Architect's Field Report

| 201 Park Court, Suite B Ridgeland, MS 39157 P 601.790.9432 F 888.281.0547 | 21 October 2020 | |
|--|---|--|
| | 18050-South Park Elementary / Report Number 021 | |

Figure 9 – Base Installed; preformed corners are required at inside and outside corners per spec

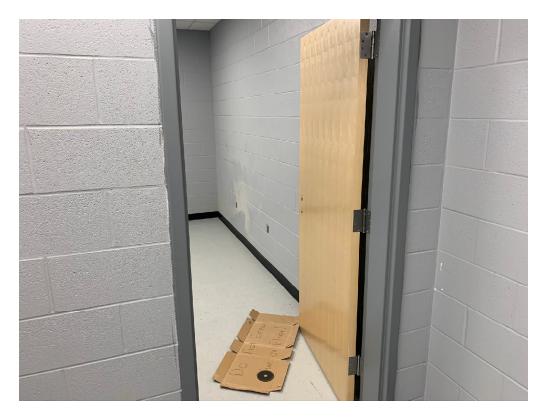
| 201 Park Court, Suite B Ridgeland, MS 39157 P 601.790.9432 F 888.281.0547 | 21 October 2020 | |
|--|---|--|
| | | Inside, flooring has been installed and painters were at work touching up. Base at the new floor is of good workmanship, however it does not have preformed corners as required in specifications. |

| 201 Park Court, Suite B Ridgeland, MS 39157 P 601.790.9432 F 888.281.0547 | 21 October 2020 | |
|--|---|--|
| | Action Required | Install Preformed Corners |
